# Memorandum

To	Douglas Shire Council and Department of State Development, Manufacturing, Infrastructure and Planning		
From	Sarah Wilson - GHD	Tel	+61 7 5413 8133
Subject	Response to information request from Douglas Shire Council (DSC) and Department of State Development, Manufacturing, Infrastructure and Planning (DSDMIP) Wangetti Trail SP1 - Combined Development Application Response to request for information 1909-13127 SRA	Job no.	4132458

We refer to the Development Application Council Ref: CA3212/2019 and SARA Ref:1909-13127 SRA associated with the proposed Wangetti Trail SP1 and provide responses to the information request issued by Douglas Shire Council (DSC) and Department of State Development, Manufacturing, Infrastructure and Planning (DSDMIP) in accordance with Part 3, Section 13.1 of the Development Assessment Rules.

Print date: 31 Oct 2019 - 12:23

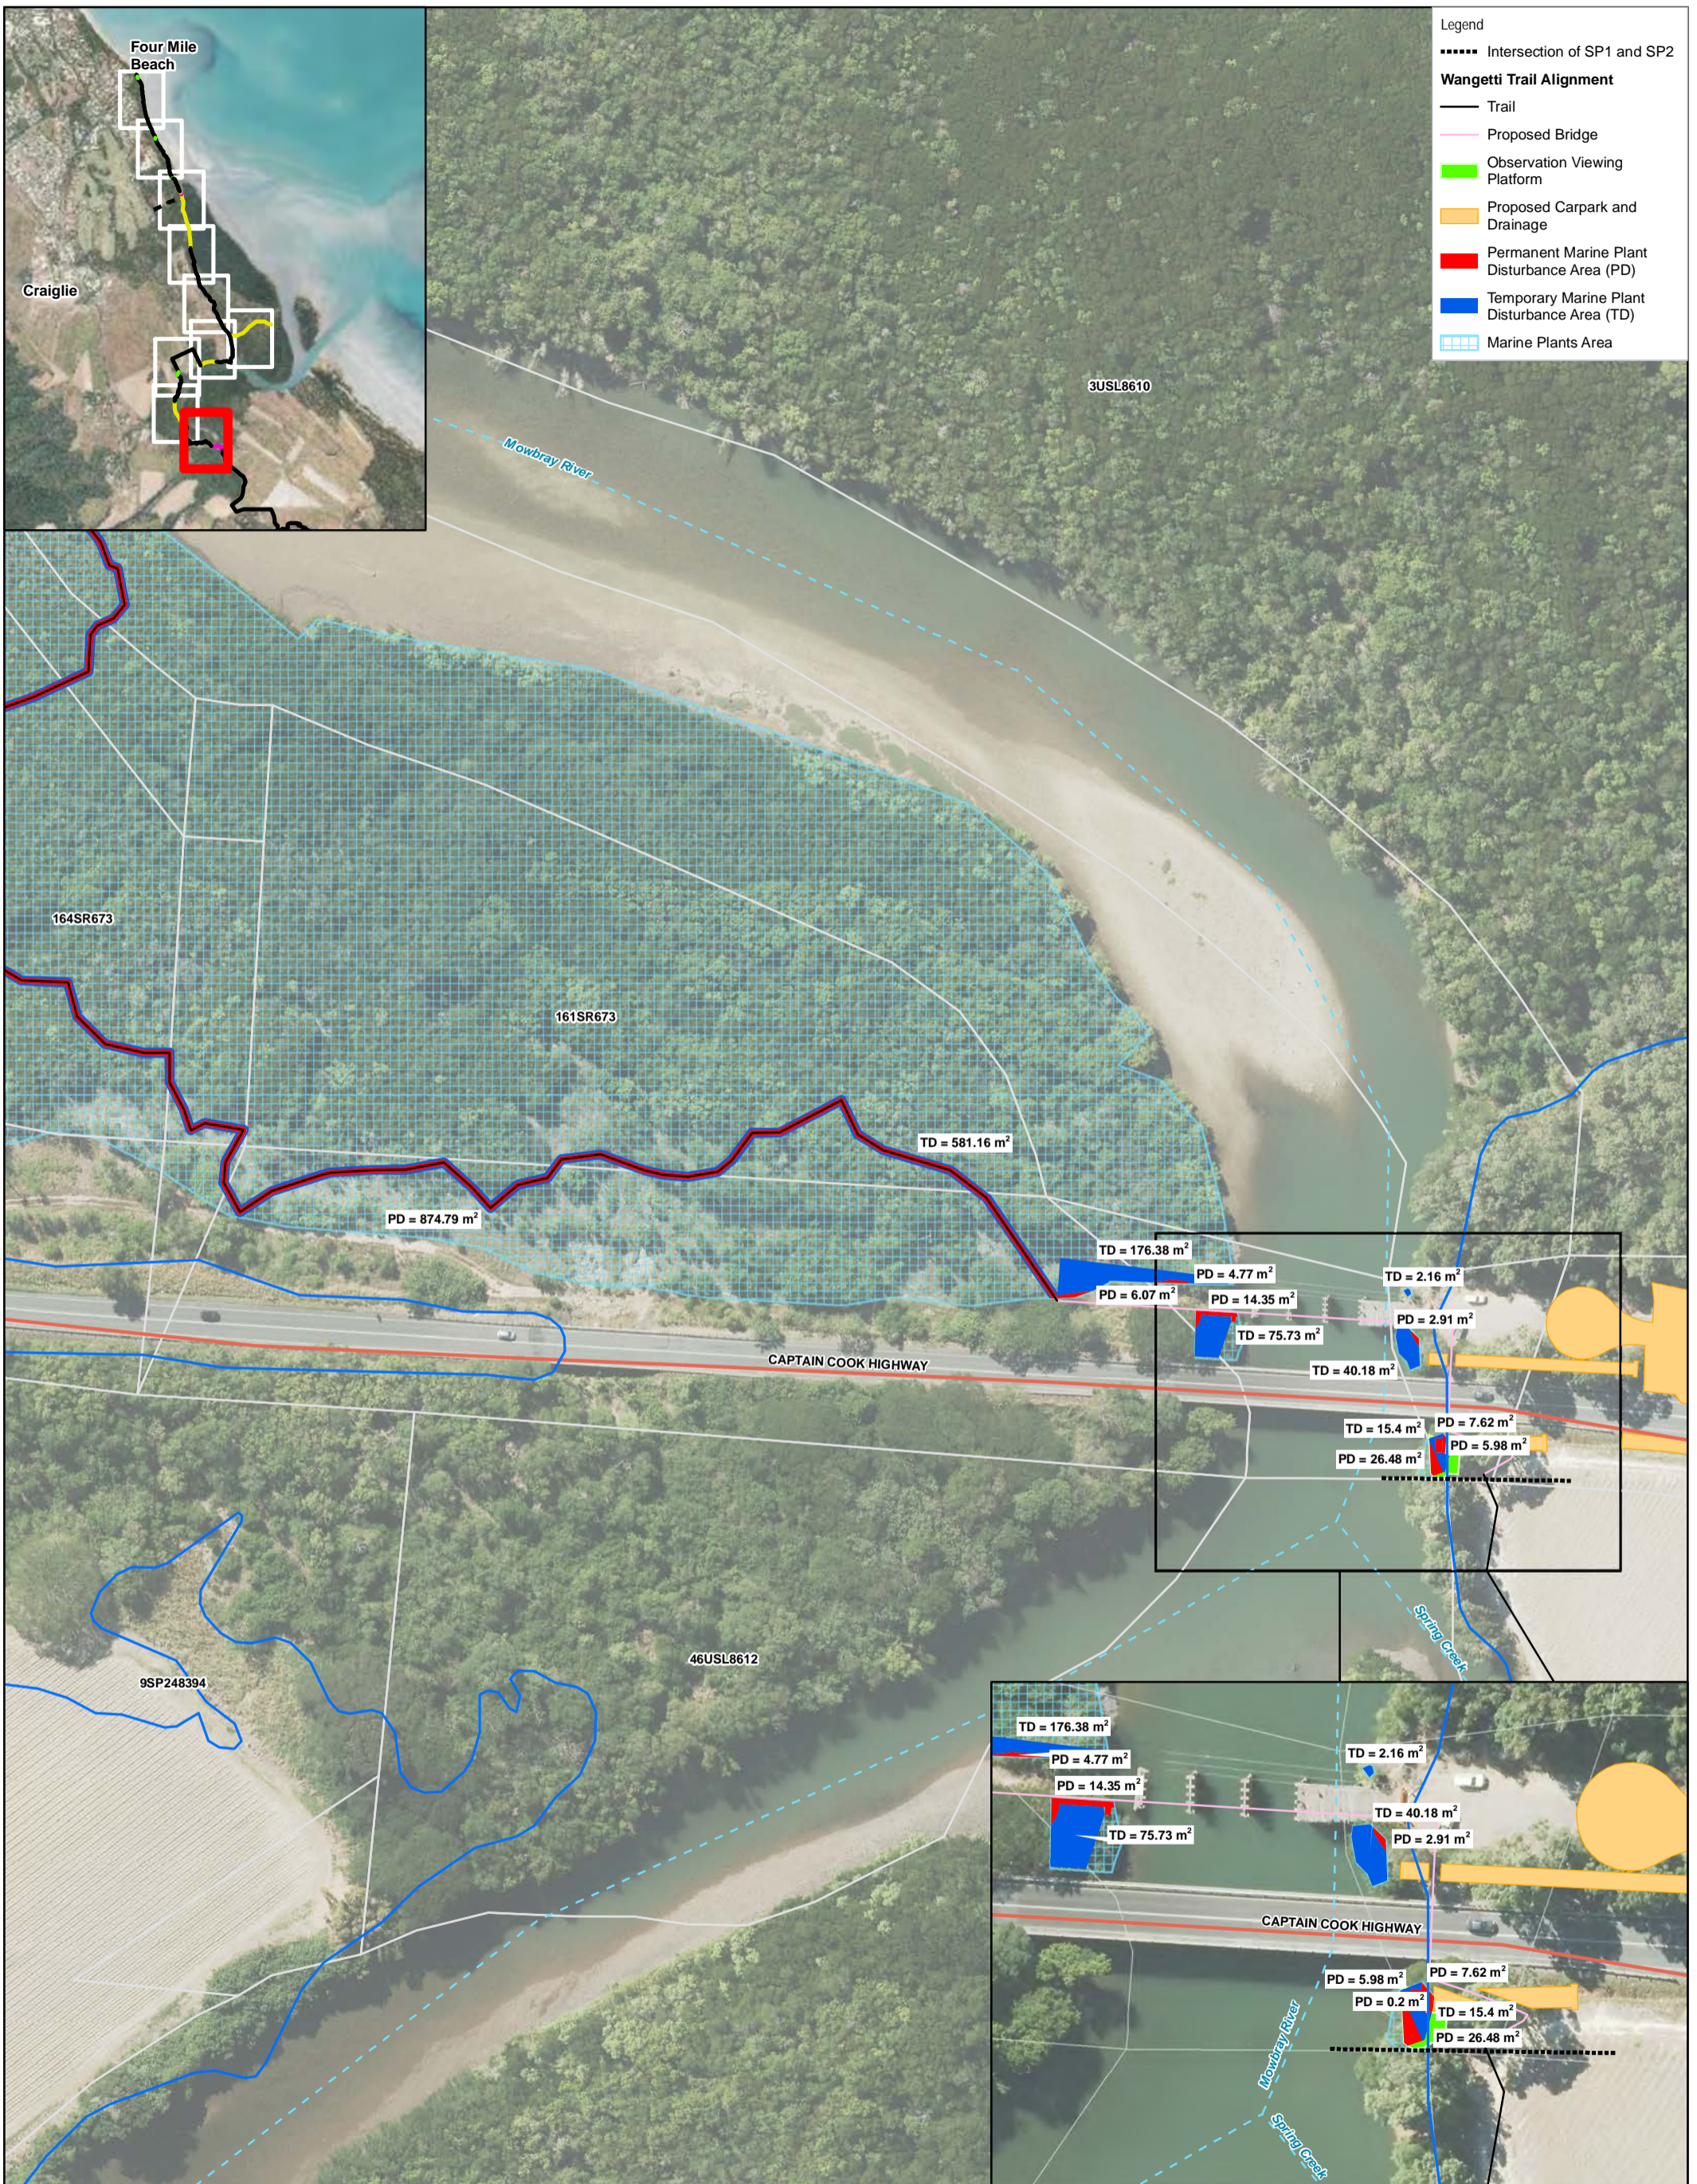
- b) *Provide maps identifying all locations where the trail will be constructed within TEC communities.*
- c) *Identify all locations where crushed rock will be used to construct the track and any creek crossings where rocks are proposed.*
- d) *Provide detailed information of the compacted trail construction and the impacts it will have to the existing profiles of tidal land.*
- e) *Demonstrate the compacted trail will not impact tidal flow and fragment tidal lands.*
- f) *Provide information of the existing tidal land levels (i.e. contour lines).*
- g) *Discuss the natural tidal inundation levels and connectivity of all adjacent habitat under elevated flow events. This discussion should include any impacts the proposed works will have on the existing connectivity.*
- h) *Discuss all potential impacts the proposed works will have on marine plants and fisheries resources.*

**Item 3 (c) Provide the individual marine plant disturbance area in meters squared (m<sup>2</sup>) for each works component.**

Figure 2 shows the location of the proposed trail and boardwalk and the location of threatened ecological community (TEC) - Littoral rainforests and coastal vine thickets of eastern Australia. The SP1 alignment has been designed to predominantly avoid areas of TEC, however the trail intersects with a small area of TEC, located approximately 600 m north of the Mowbray River. The TEC was not previously mapped in government databases and was recorded during the site investigation of the area. Based on the composition of the vegetation within the TEC area, it was determined not to contain high fisheries significant plants.

A breakdown of the marine plant disturbance including temporary and permanent disturbance has been provided in Table 3-2 of the Environment Assessment Stage 2 Wangetti Trail Planning Report for Operational Work - SP1 Marine Plant Disturbance Report and is outlined in Table 5 below and shown in Figure 2.

**Figure 3 Locality SP1**

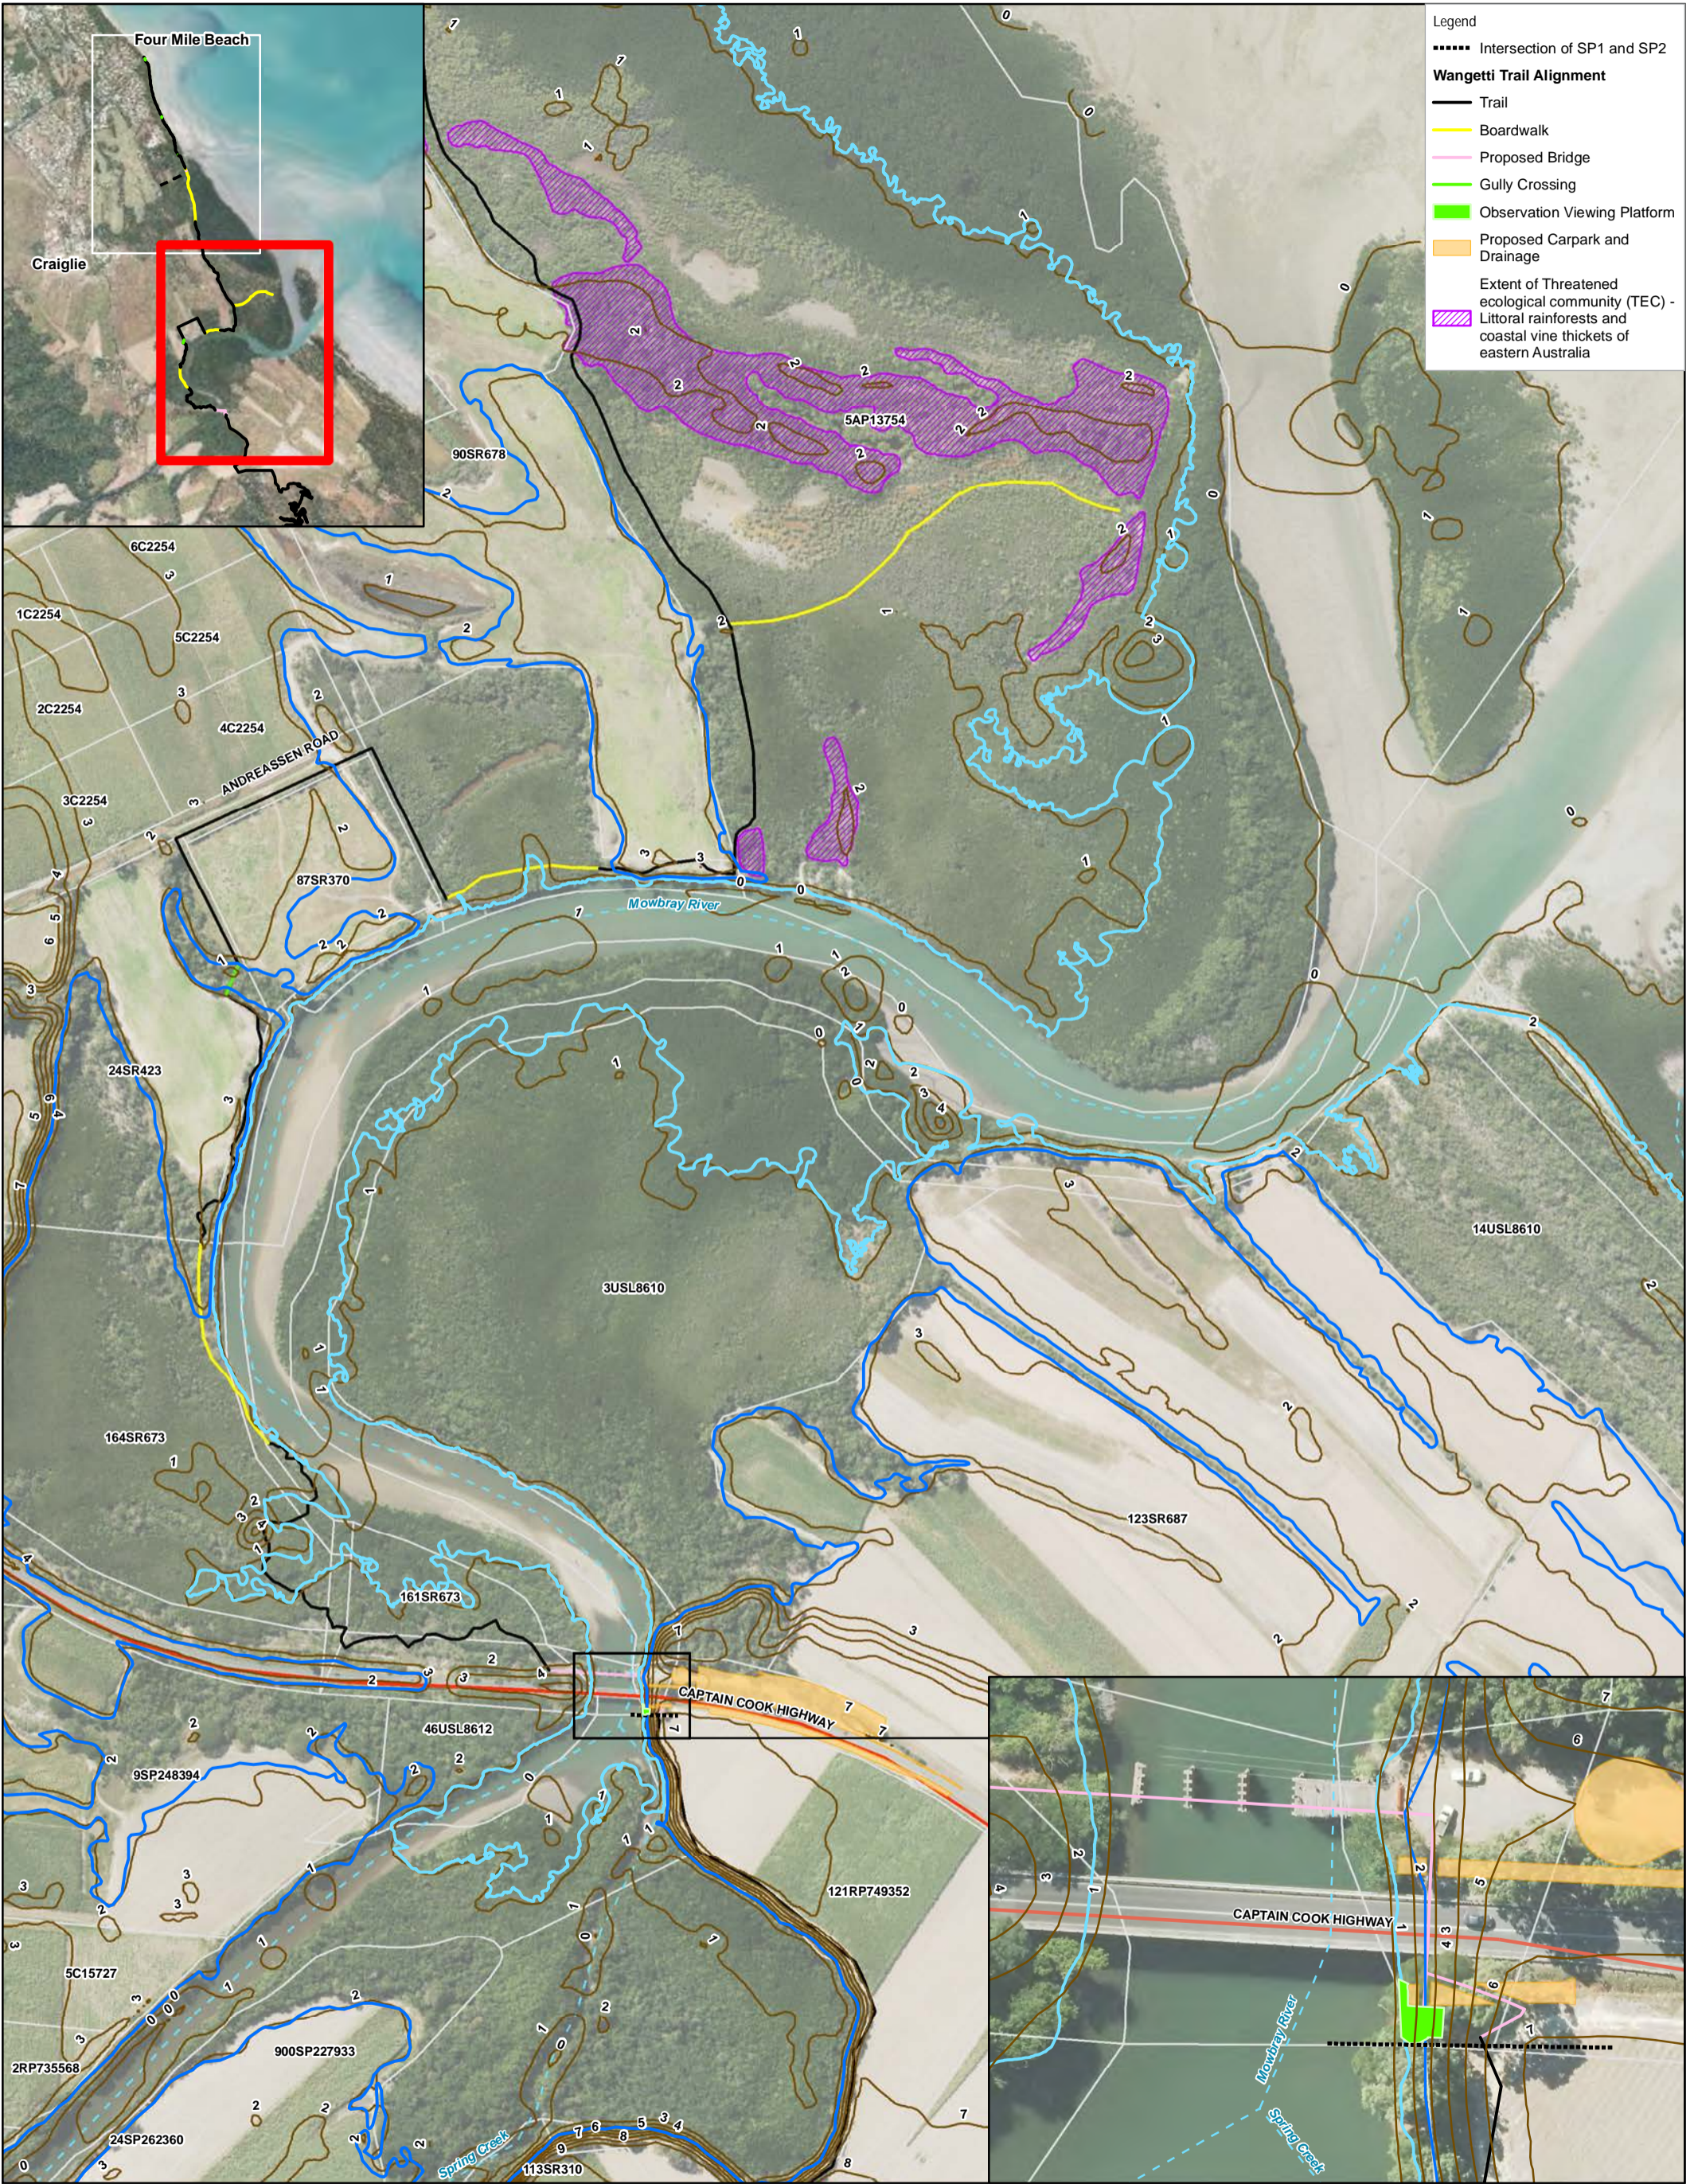
**Item 2 (f) Provide information of the existing tidal land levels (i.e. contour lines)**

Figure 3 shows the location of the proposed works for Wangetti Trail SP1 as well as the following additional information:

Refer to the response provided to Item 2 (f) in Section 2.1 and refer Figure 3, which identifies the location of the Wangetti Trail SP1, the existing tidal land levels and contour lines.
